RAINIER SQUARE REDEVELOPMENT RECOMMENDATION MEETING

Design Review Submittal # 2

Address: 1301 5th Ave., Seattle, WA 98101

DRB #2 Review Date: June 23, 2015

D.1 Relationship to Existing Rainier

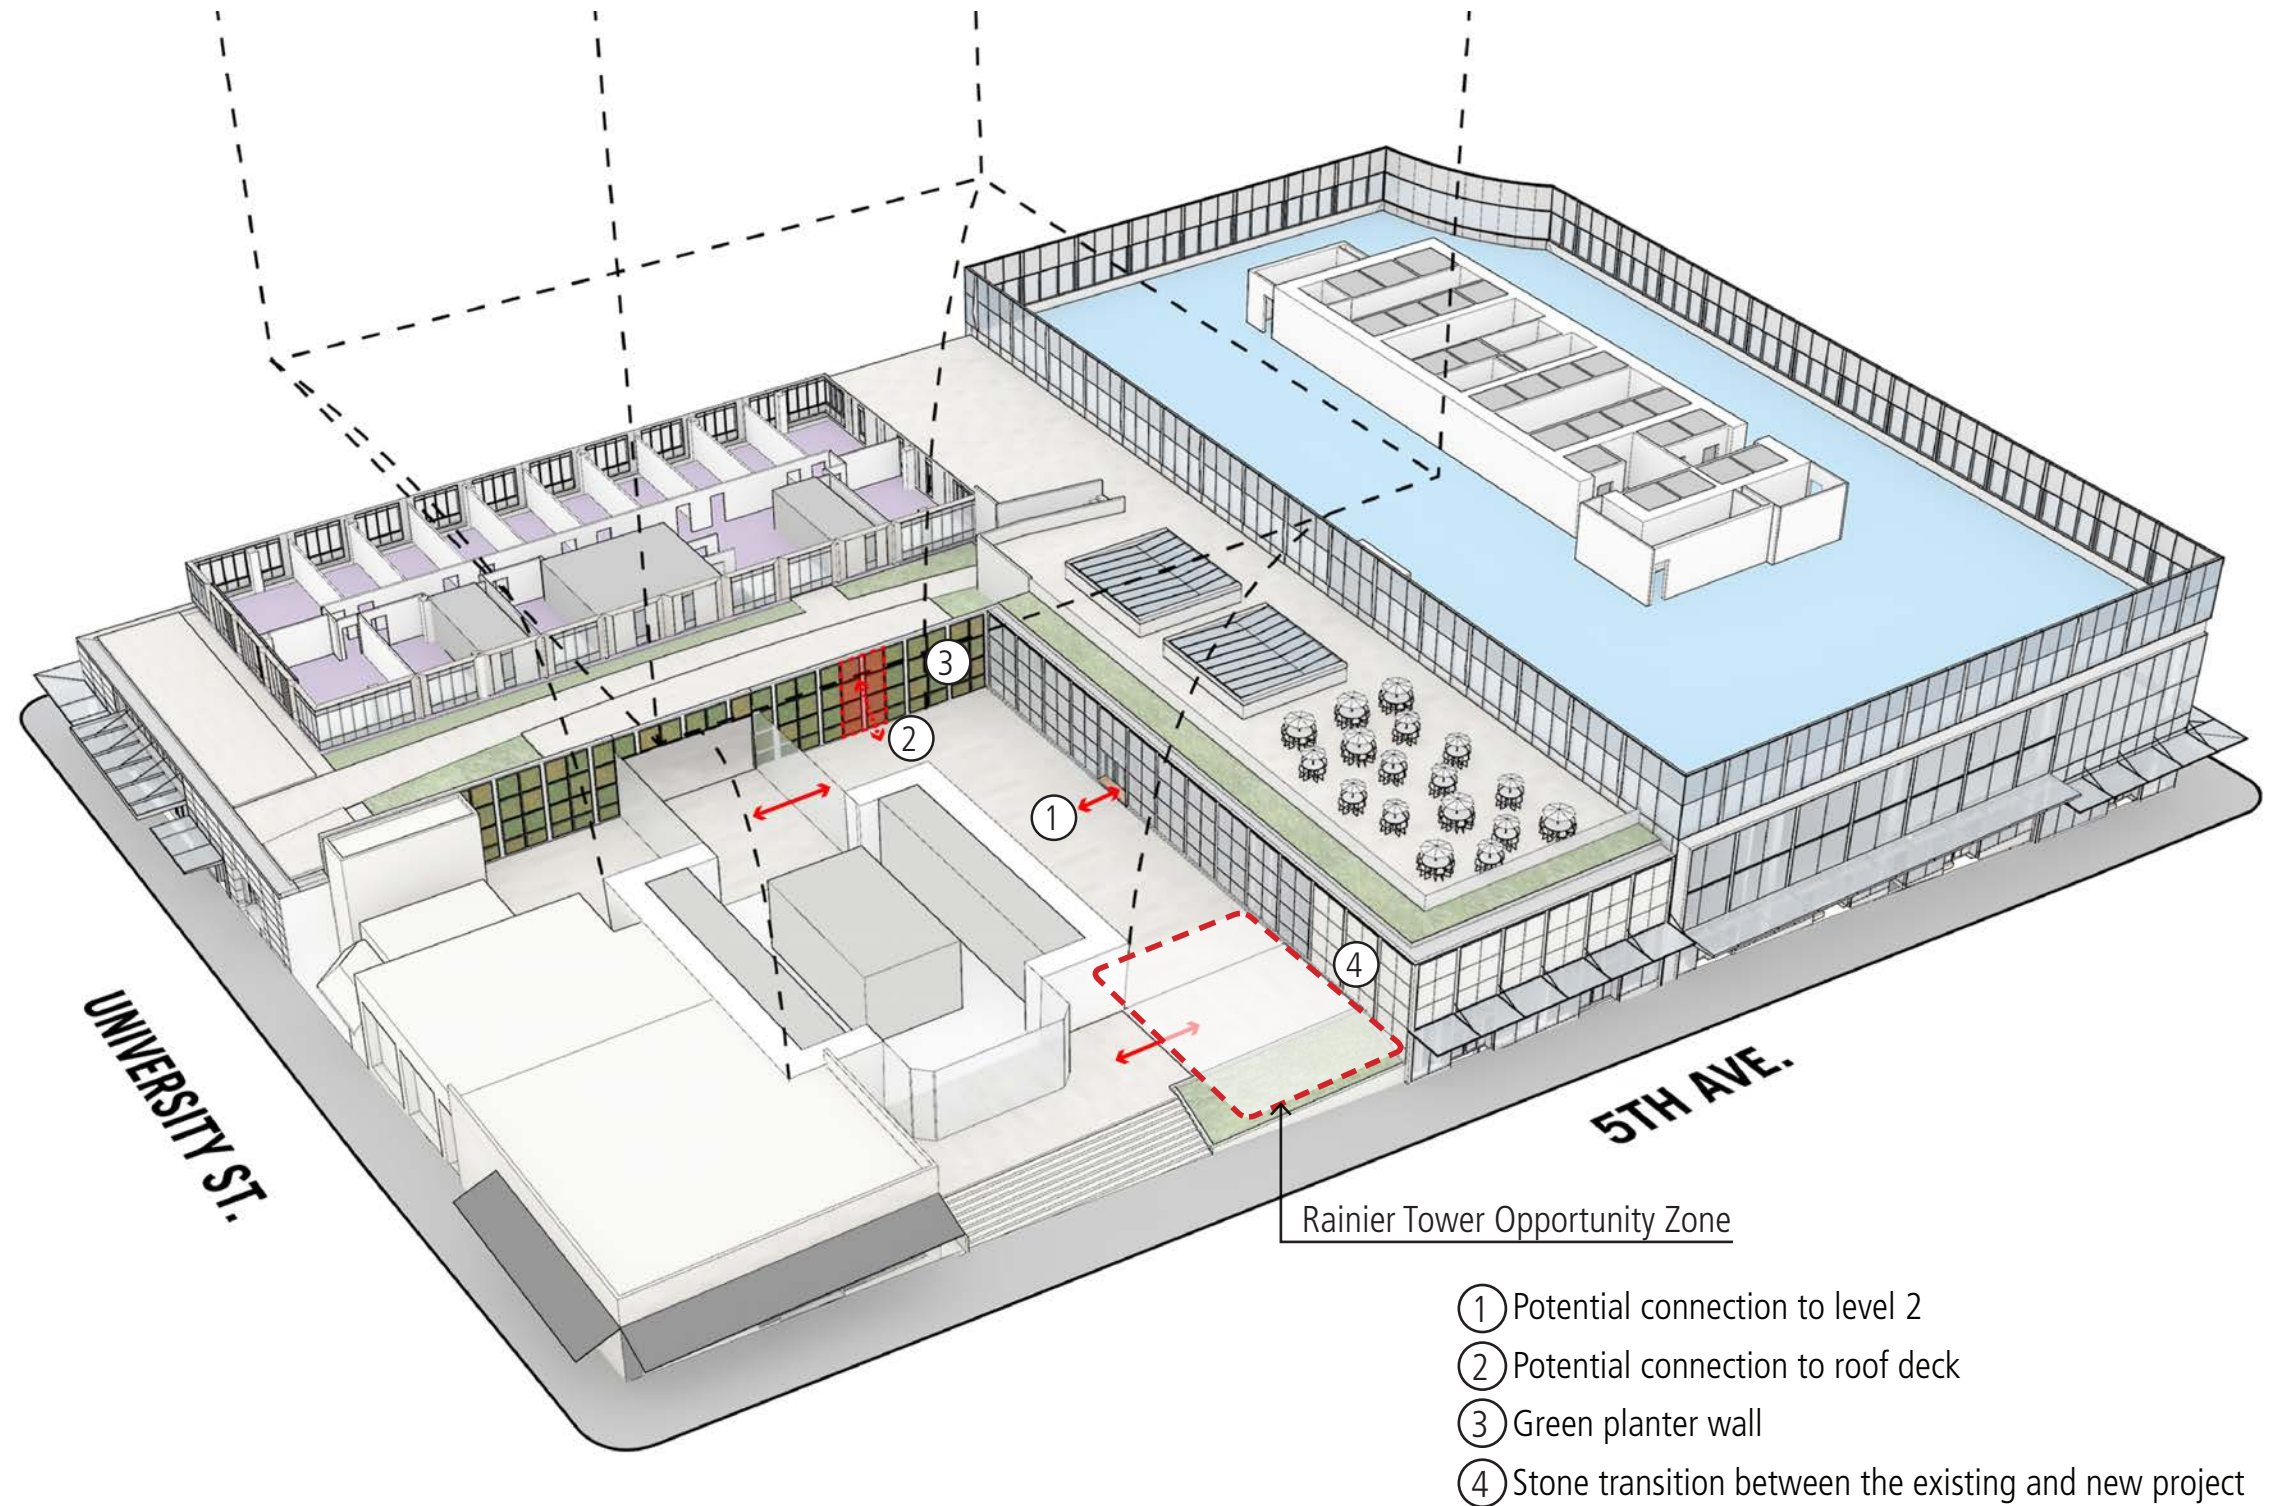
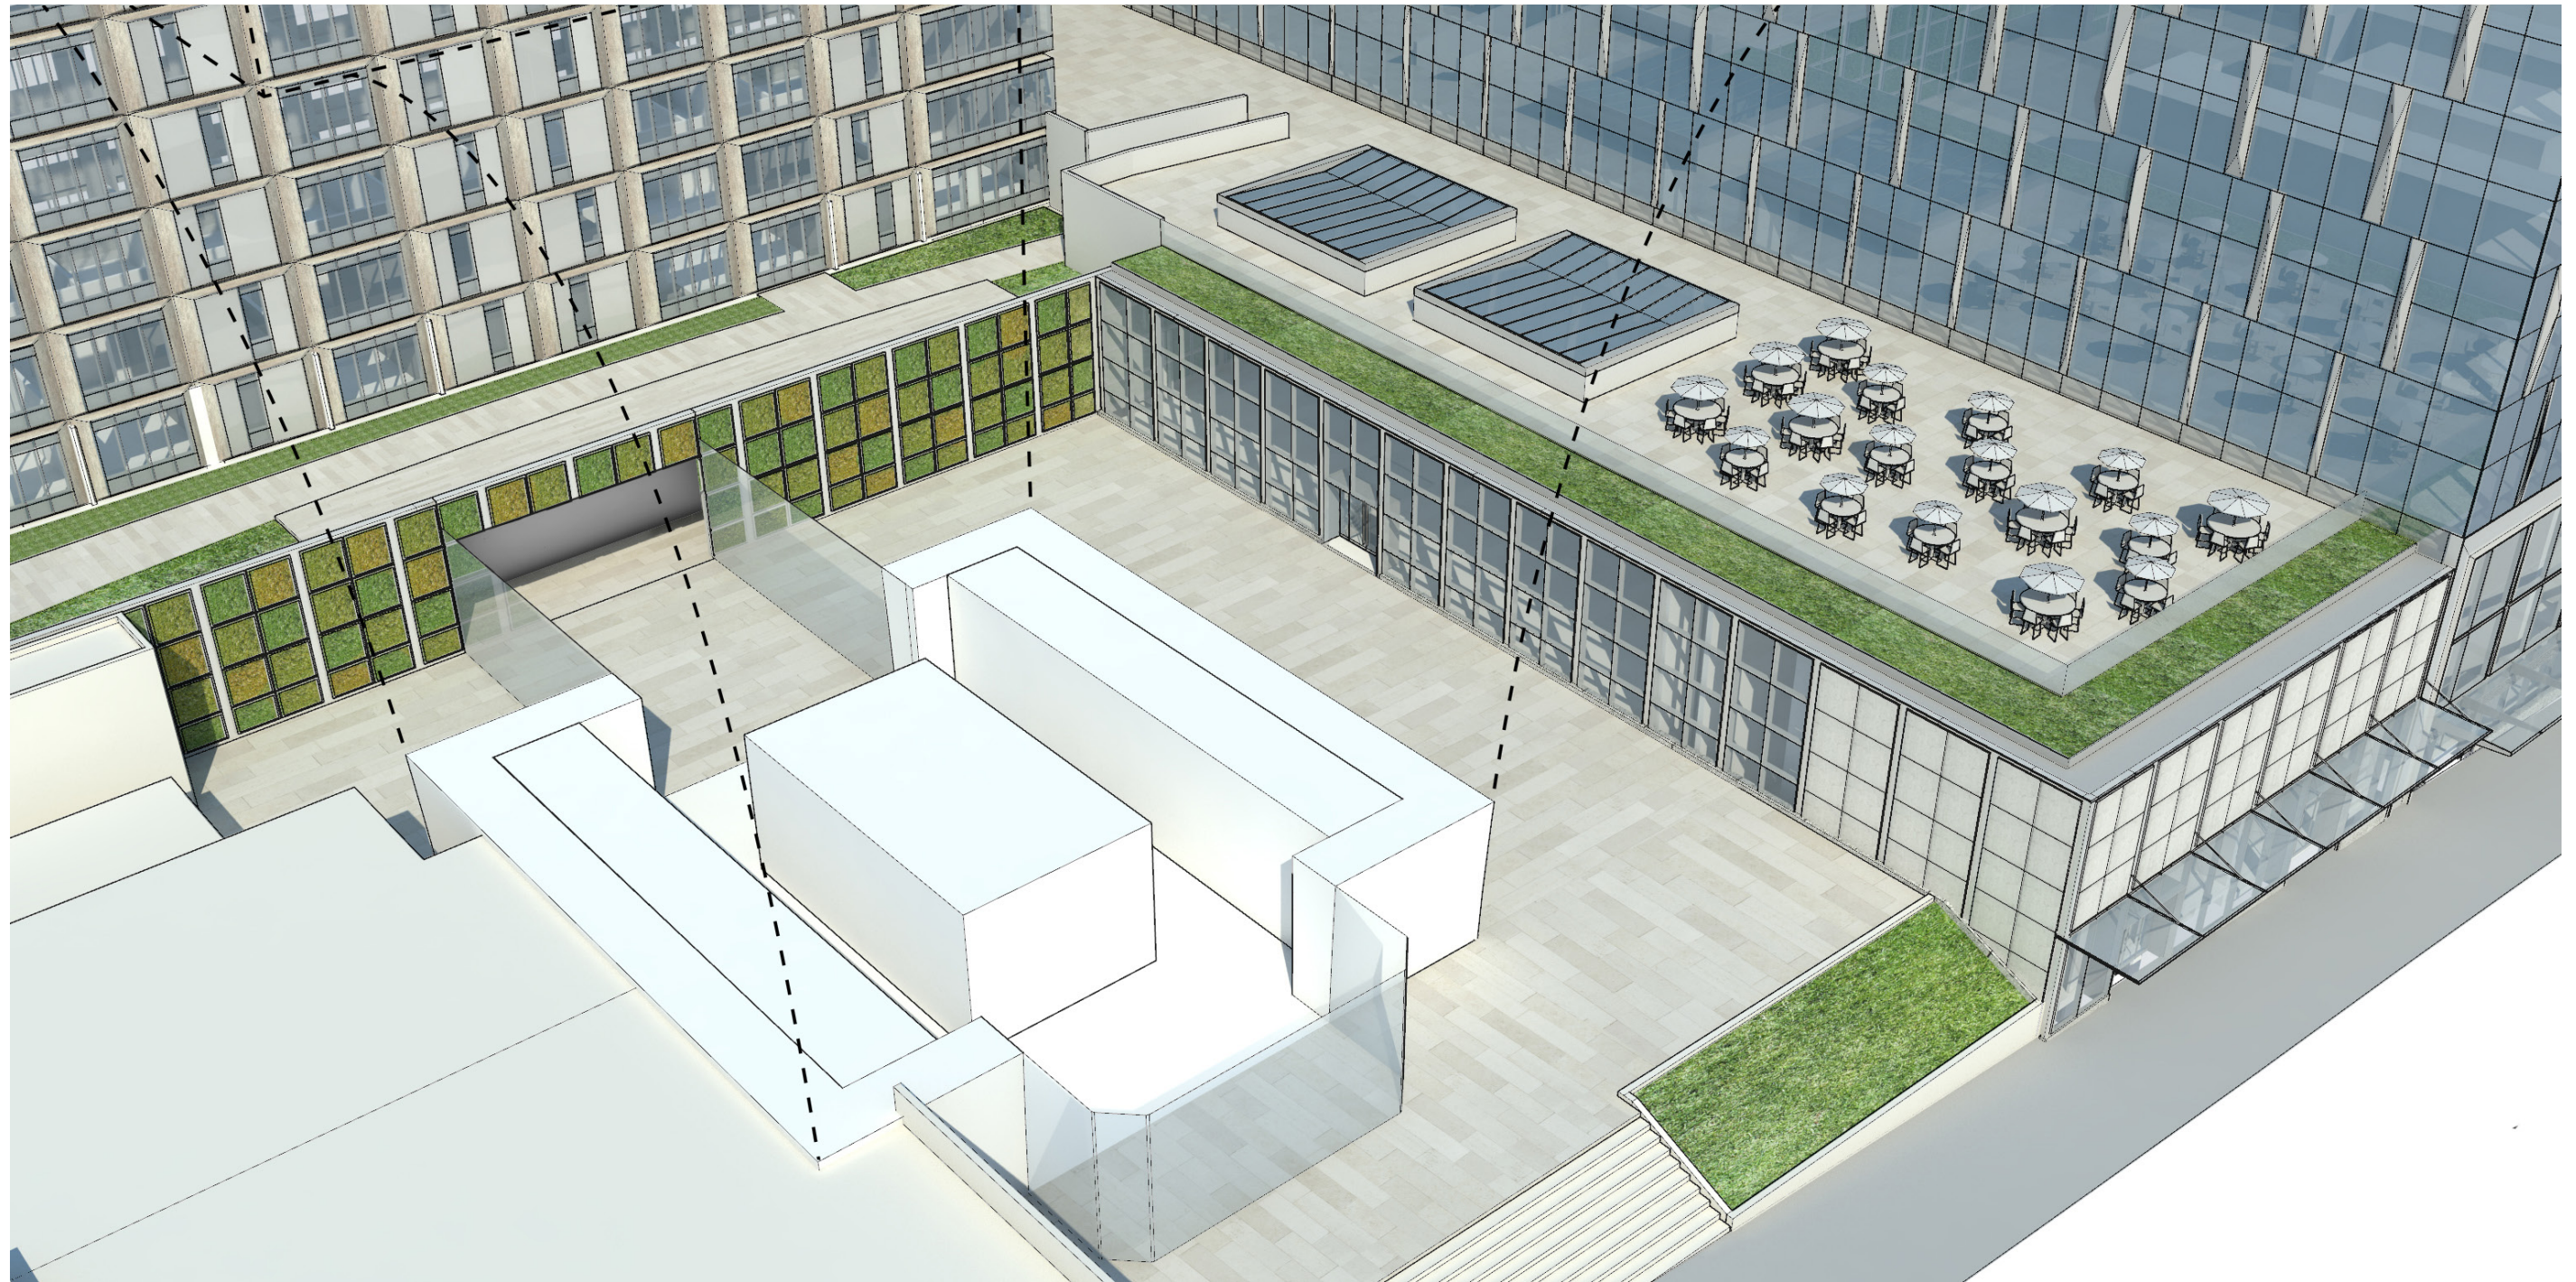
The Board questioned the applicant on how the current landscaping surrounding the Rainier Tower base would connect with the new development. Stairs and other features would need to be redesigned. The south wall of the retail space facing Rainier Square would also have to be well detailed and presented to the Board.

- While open spaces underneath the existing Rainier Tower are not part of this project, perimeter conditions have been developed to accommodate a variety of options for future connection and integration.
- Additional development and detail has been provided for the design of the south wall of the retail space facing the existing Rainier Tower.

D.2 Landscape

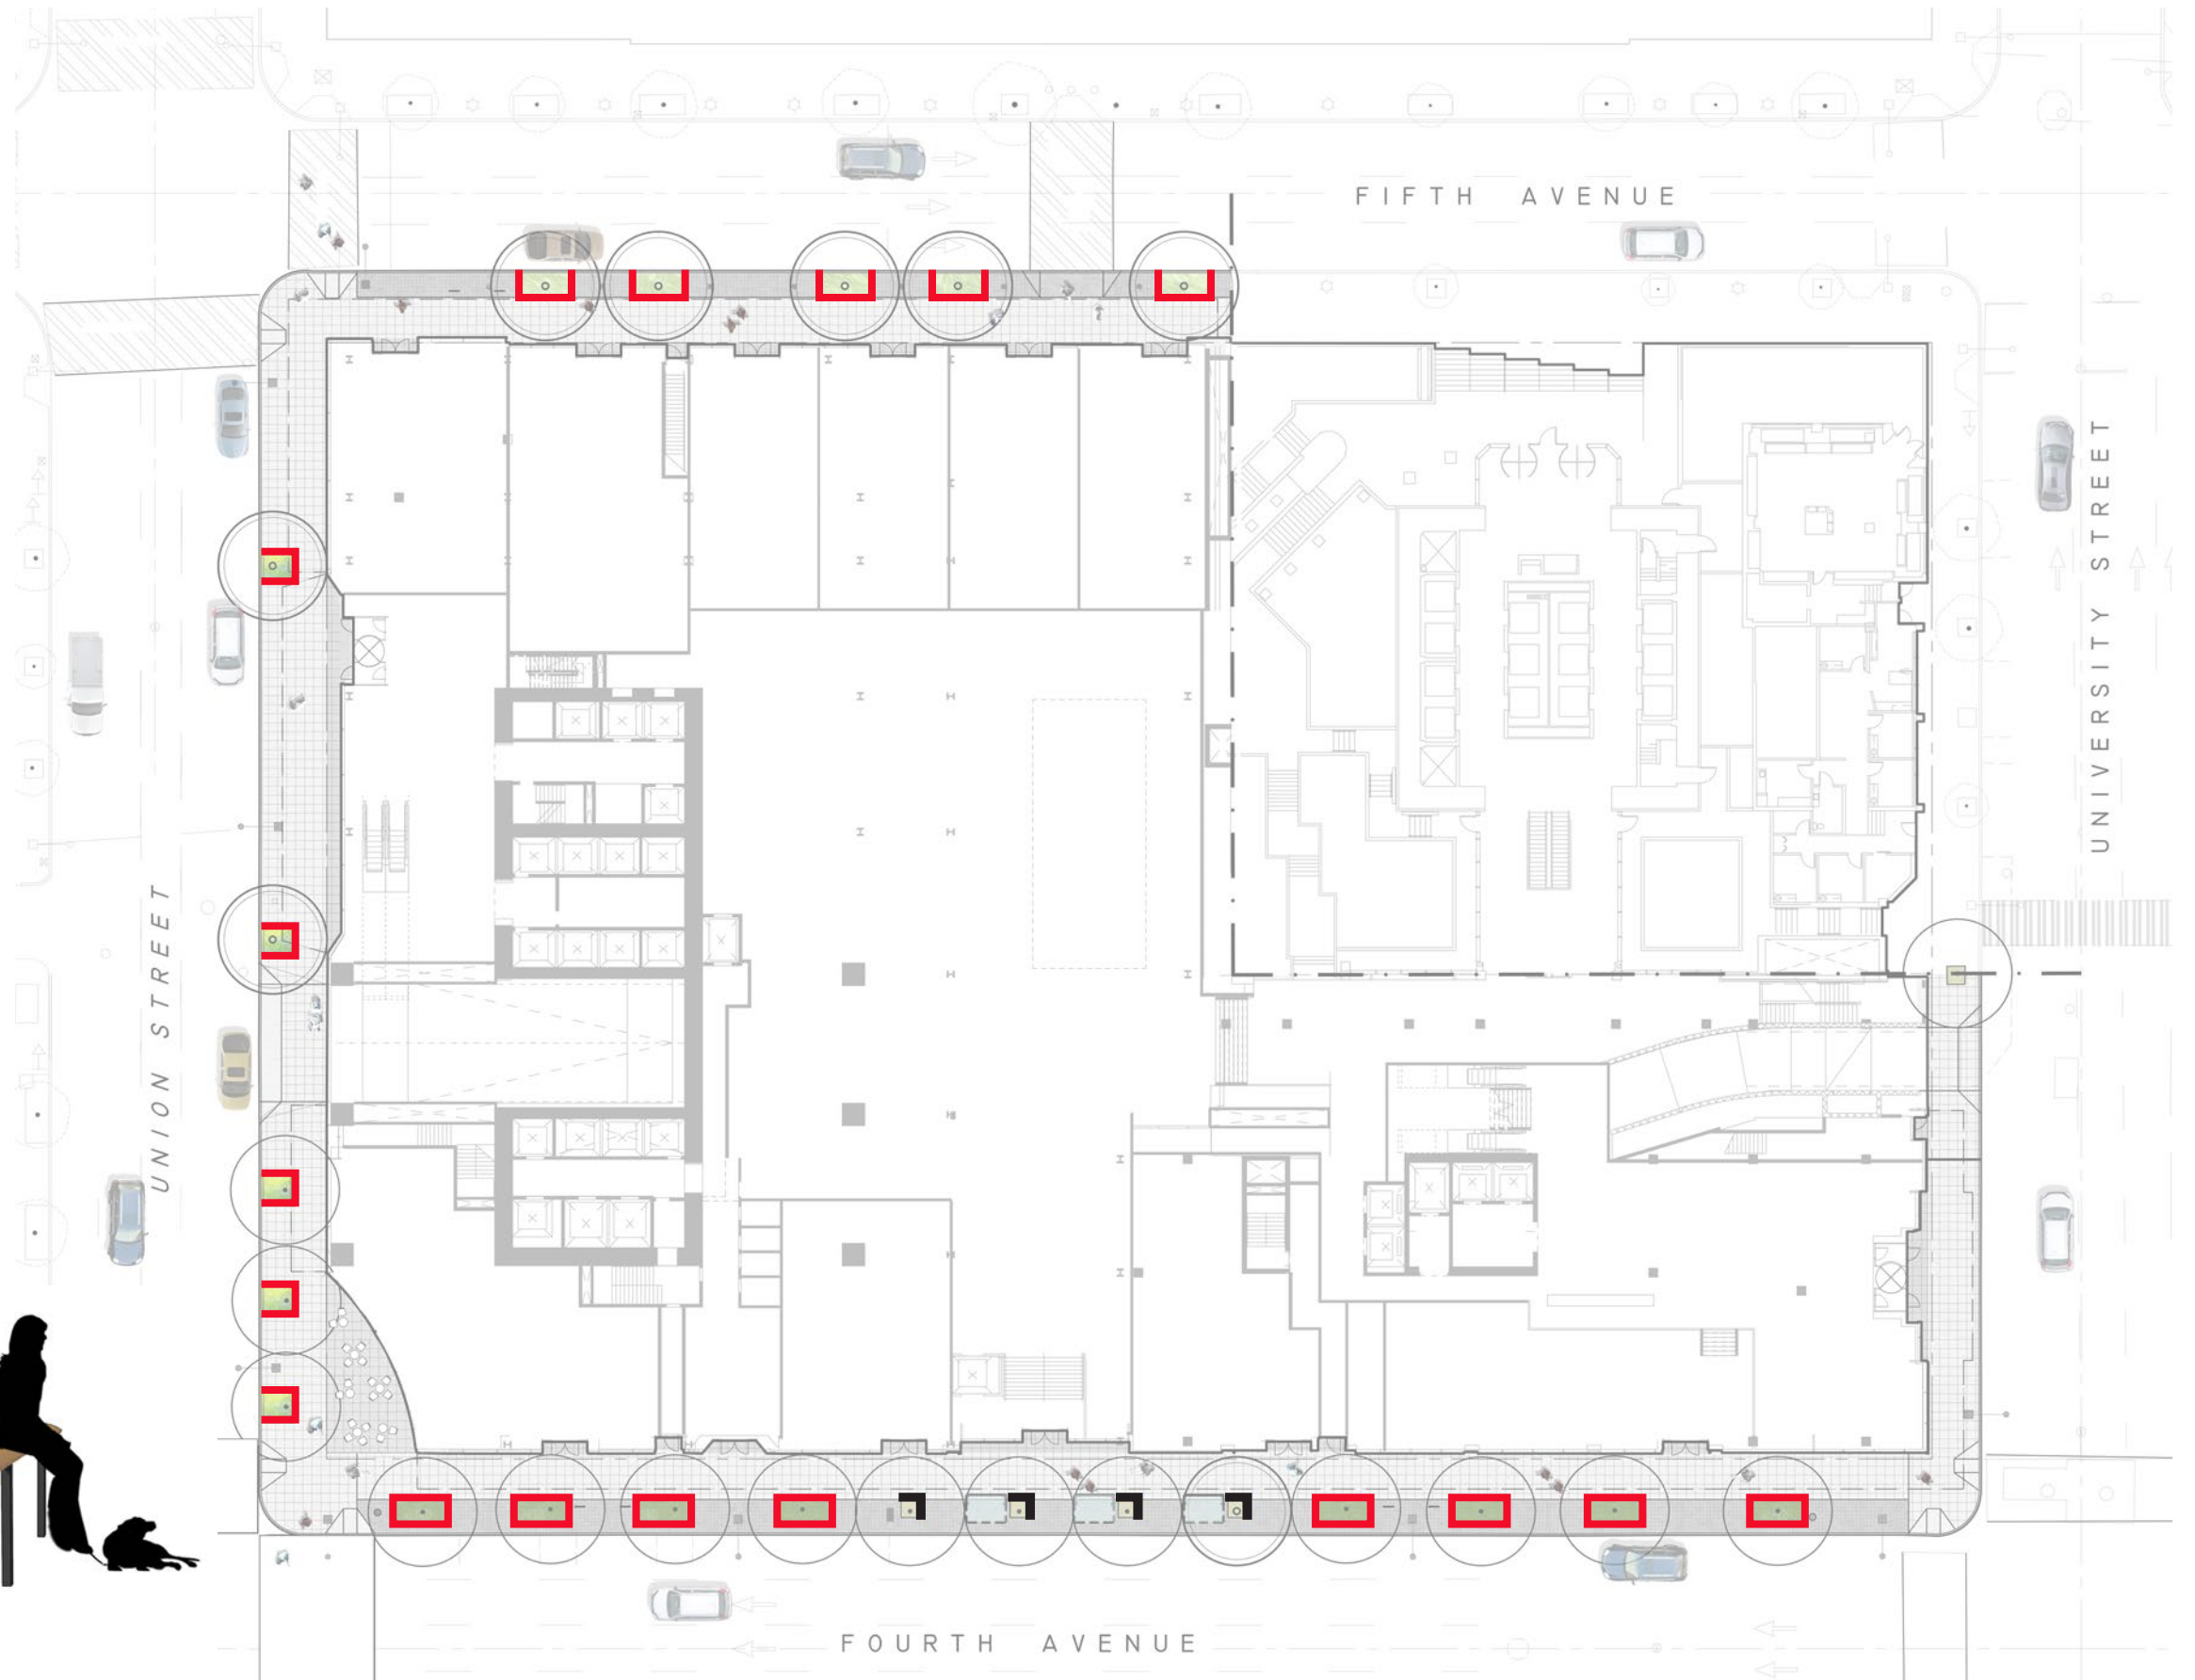
More effort should be applied to creating a common and interesting landscape language at the entries and the tree pits. Street furniture should be added that complements the landscape design. The Fourth and Union corner plaza provides an opportunity for interesting landscaping and the introduction of street furniture.

- Additional detailed design information has been provided for the planter fence lean rail details and at the tree pits.
- Detailed landscape design information has been provided for the new sidewalk plaza at 4th Avenue and Union Street.
